COMMONWEALTH of VIRGINIA

DEPARTMENT OF TRANSPORTATION
1401 EAST BROAD STREET
RICHMOND, VIRGINIA 23219-2000

January 9, 2004

The following is a list of standards contained in the 2001 Road and Bridge Standards that have been revised. Please add these pages to your copy of the standards. An insertable sheet will not be required in plan assemblies.

SHEET 1 OF 2	STANDARD CURB DROP INLET	SPECIFICATION REFERENCE
REV. 01/04. 104.03		12" - 24" PIPE: MAXIMUM DEPTH (H) = 9'

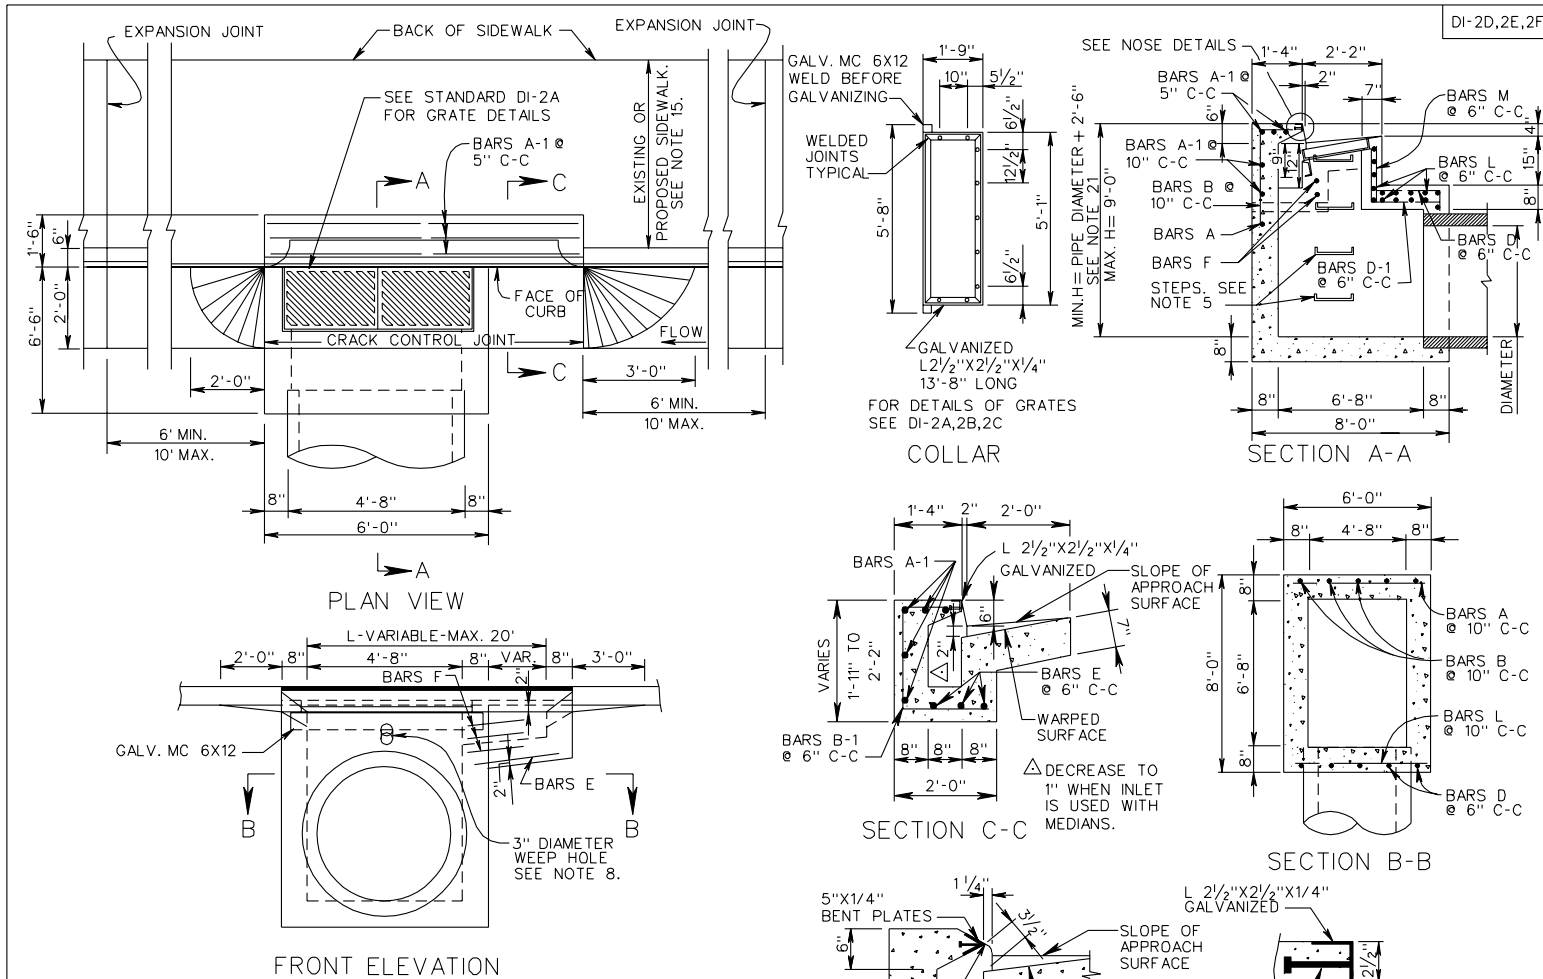
PAGE	INSERT	STANDARD	REVISION
104.03	A153	DI-2A,2B,2C	Revised details showing approach surface to slot.
104.06	A153	DI-2D,2E,2F	Revised details showing approach surface to slot.

SPECIFICATION REFERENCE	INSTALLATION OF PIPE CULVERTS AND STORM SEWERS CIRCULAR PIPE BEDDING AND BACKFILL - METHOD "A"	
302 303	VIRGINIA DEPARTMENT OF TRANSPORTATION	REV. 1/04 107.01

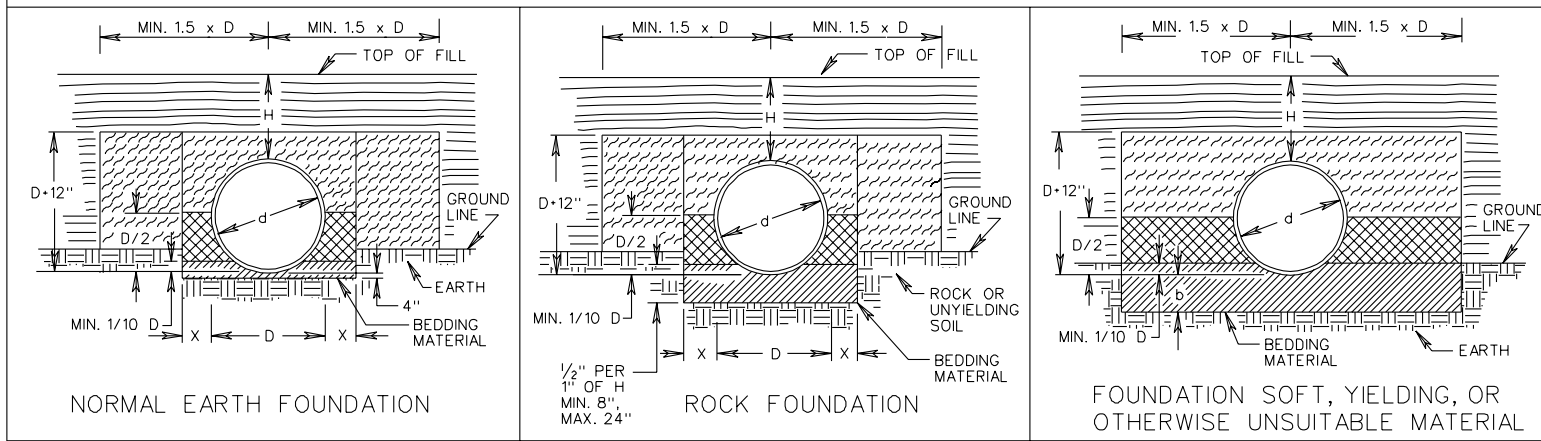
PAGE	INSERT	STANDARD	REVISION
107.00	A151	PB-1	Added Notes Page
107.01	A86	PB-1	Removed requirement for class II backfill
107.02	A86	PB-1	Removed requirement for class II backfill
107.03	A120	PB-1	Removed requirement for class II backfill
107.04	A120	PB-1	Removed requirement for class II backfill
108.06	A81	UD-4	Removed inspection port and modified outlet pipe configuration.
115.01	ISD414.04	ESC-INS	Revised entrance width from 12" to 12'
203.02	A78	CG-9B	Revised Notes.
203.03	A78	CG-9D	Revised Notes
203.05	A59	CG-12	Revised notes and dimensions.
203.06	A59	CG-12	Revised notes and dimensions.
203.07	A59	CG-12	Revised notes and dimensions.
203.08	A108	CG-13	Revised notes and dimensions.

REV. 1/04 301.14	9" THICK CONTINUOUSLY REINFORCED CONCRETE PAVEMENT 14 FOOT TRAVEL LANE	SPECIFICATION REFERENCE
	VIRGINIA DEPARTMENT OF TRANSPORTATION	316

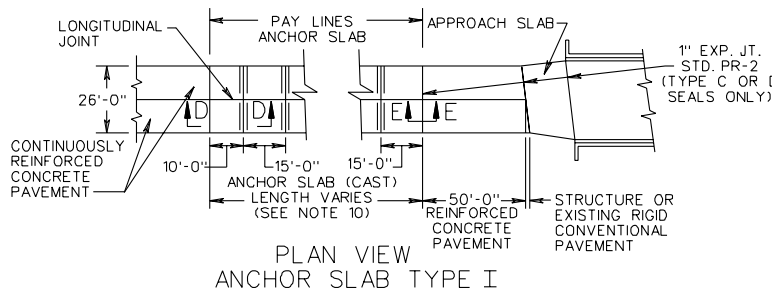
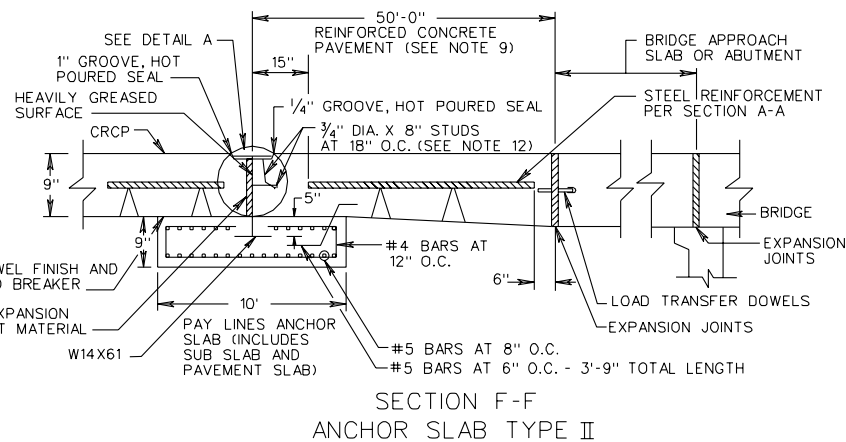
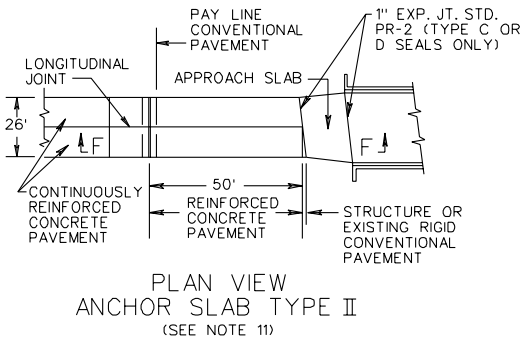
PAGE	INSERT	STANDARD	REVISION
301.14	ISD2623	PR-5	Revised anchor slab detail.
301.17	ISD2724	PR-6	Revised anchor slab detail.
301.20	ISD2761	PR-7	Removed load transfer dowel into bridge (section F-F).Revised anchor slab detail.

SHEET 2 OF 3		SEE SHEET 3 OF 3 FOR NOTES	
SPECIFICATION REFERENCE	12" THICK CONTINUOUSLY REINFORCED CONCRETE PAVEMENT 14' TRAVEL LANE		
316	VIRGINIA DEPARTMENT OF TRANSPORTATION		REV. 1/04 301.23

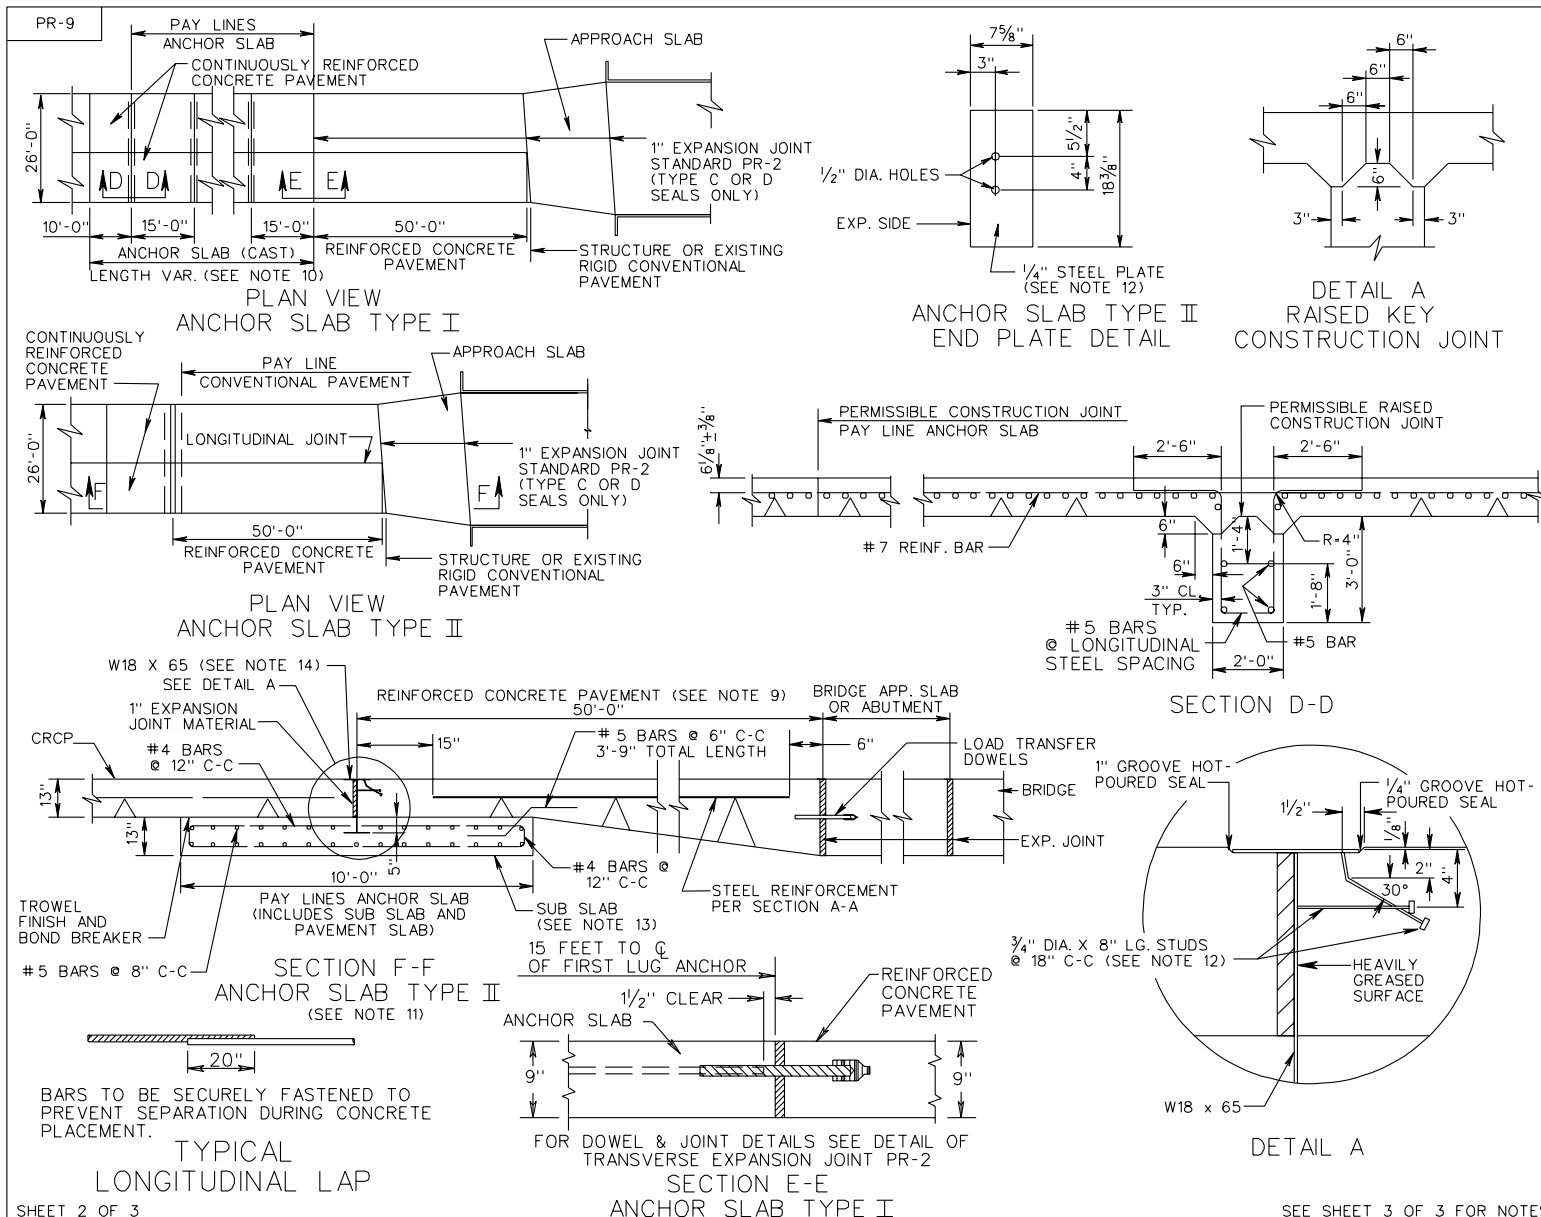
301.23	ISD2861	PR-8	Removed load transfer dowel into bridge (section F-F).Revised anchor slab detail.
301.26	ISD2862	PR-9	Removed load transfer dowel into bridge (section F-F).Revised anchor slab detail.

REV. 1/04
501.15

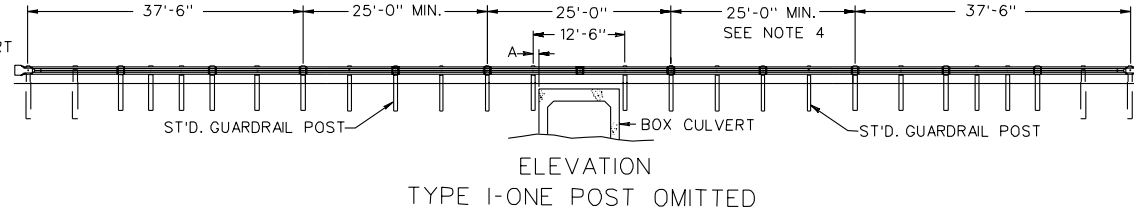
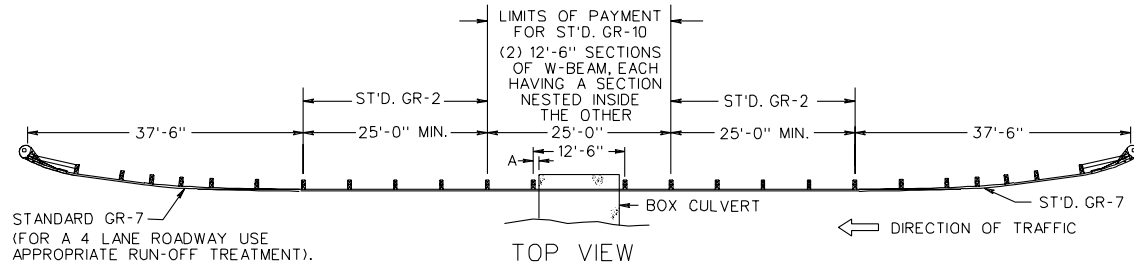
501.15	A91	GR-8,8A,8B,8C	Revised notes referring to limits of item.
501.19	A88	GR-10	Revised note to remove reference to splice plate.
501.20	A88	GR-10	Revised detail changing text from "Clear Zone" to "Dynamic Deflection". Revised note to remove reference to splice plate.

501.39

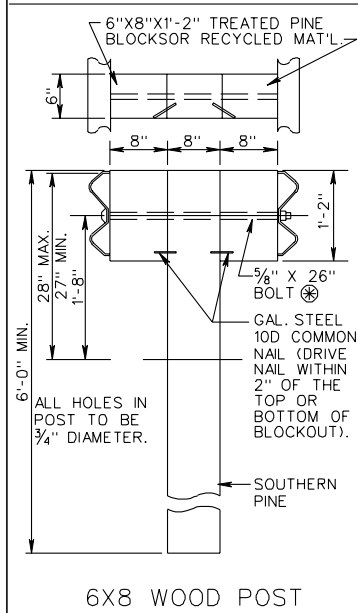
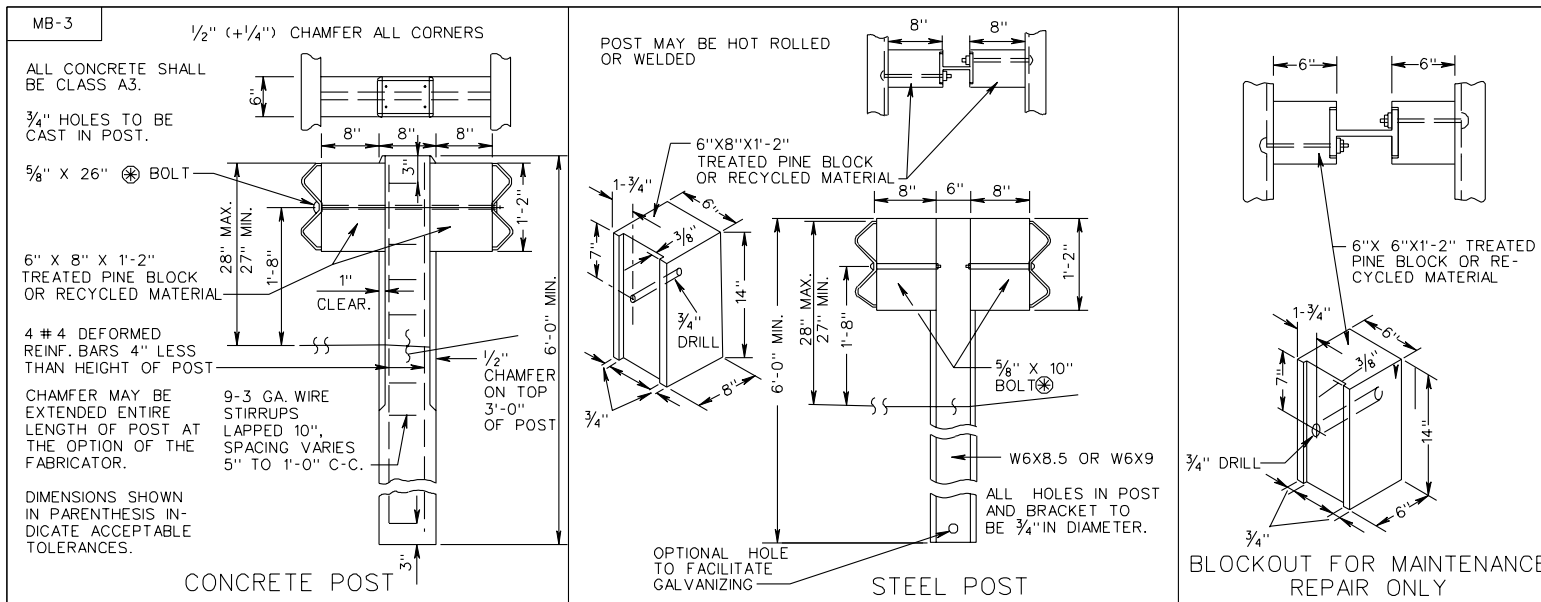
501.39	A93	GR-INS	Added detail for transition from old GR-8 to current standard.
501.41	A94	MB-3	Revised flare rates.
501.44	A98	MB-7D, 7E, 7F	Revised flare rates.

REV.1 /04
501.45

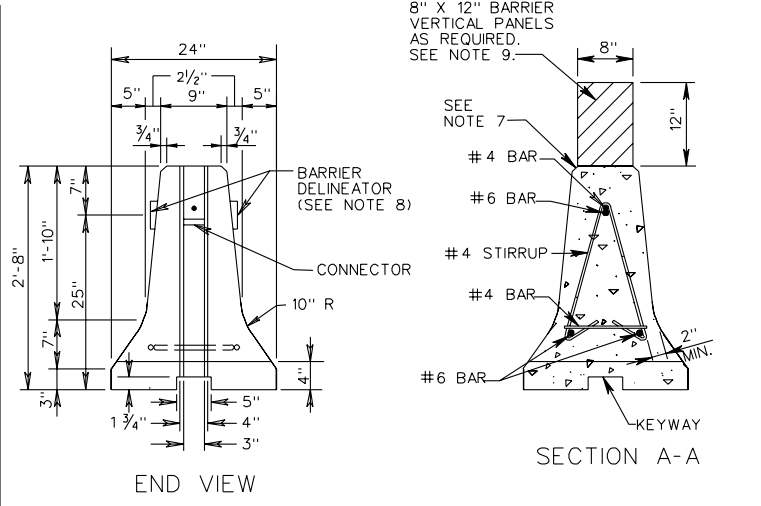
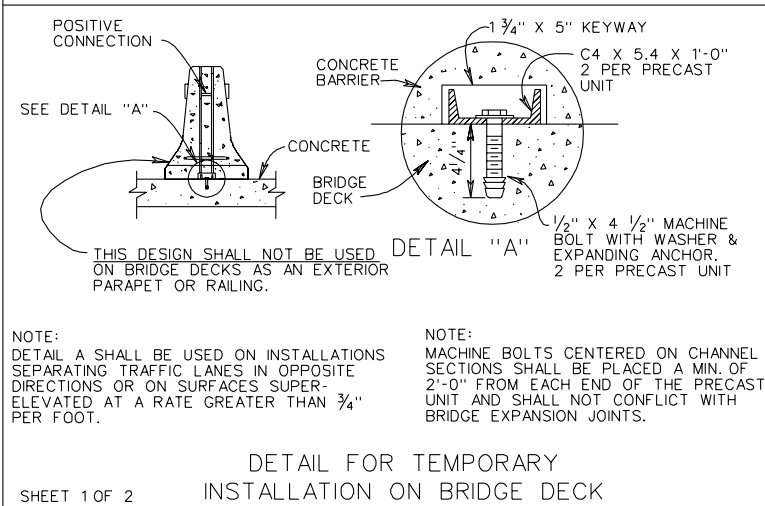
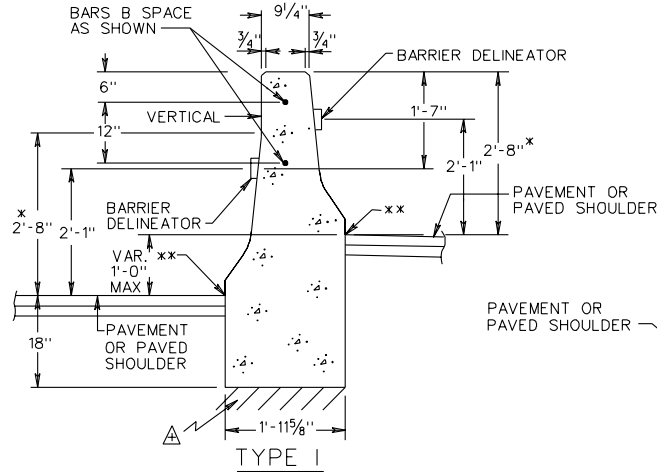
501.45	A103	MB-7D PC	Revised flare rates.
501.47	A98	MB-8A	Revised flare rates

DESIGN SPEED	FLARE RATES *		
	INSIDE SHY LINE	BEYOND SHY LINE	
MPH	SHY LINE LS	FLARE RATE	FLARE RATE
70	10'	30:1	20:1
60	8'	26:1	18:1
50	6.5'	21:1	14:1
40	5'	16:1	10:1
30	3.5'	13:1	8:1

501.56

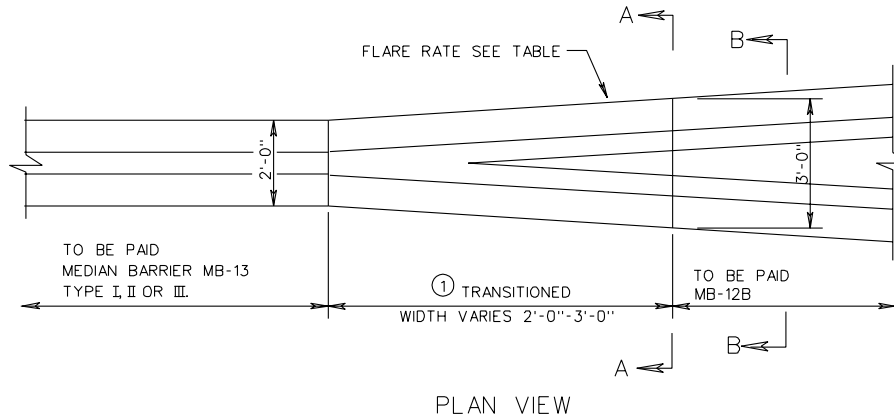
PAGE	INSERT	STANDARD	REVISION
501.56	A96	MB-12A,B,C	Revised flare rates.
501.58	A104	MB-13	Revised flare rates.
502.04	A152	FE-CL	Revised Specification Designation of post sizing.
502.07	A152	FE-6	Revised notes.
603.02	A149	RFD-1	Revised table dimension from Ft. to In.
1301.72	A154	OSS-1	Added Note #6 and revised fixed object offset distance.
1301.73	A154	OSS-1	Deleted catwalks and replaced details with electrical installation details and added a contactor.
1301.74	A155	OSS-1	Replaced details with sign panel erection details and sign lighting details.
1301.75	A155	OSS-1	Replaced details with sign panel erection details and sign lighting details.

DESIGN SPEED	FLARE RATES		
	INSIDE SHY LINE	BEYOND SHY LINE	
MPH	SHY LINE LS	FLARE RATE	FLARE RATE
70	10'	30:1	20:1 *
60	8'	26:1	18:1 *
50	6.5'	21:1	14:1 *
40	5'	16:1	10:1 *
30	3.5'	13:1	8:1 *
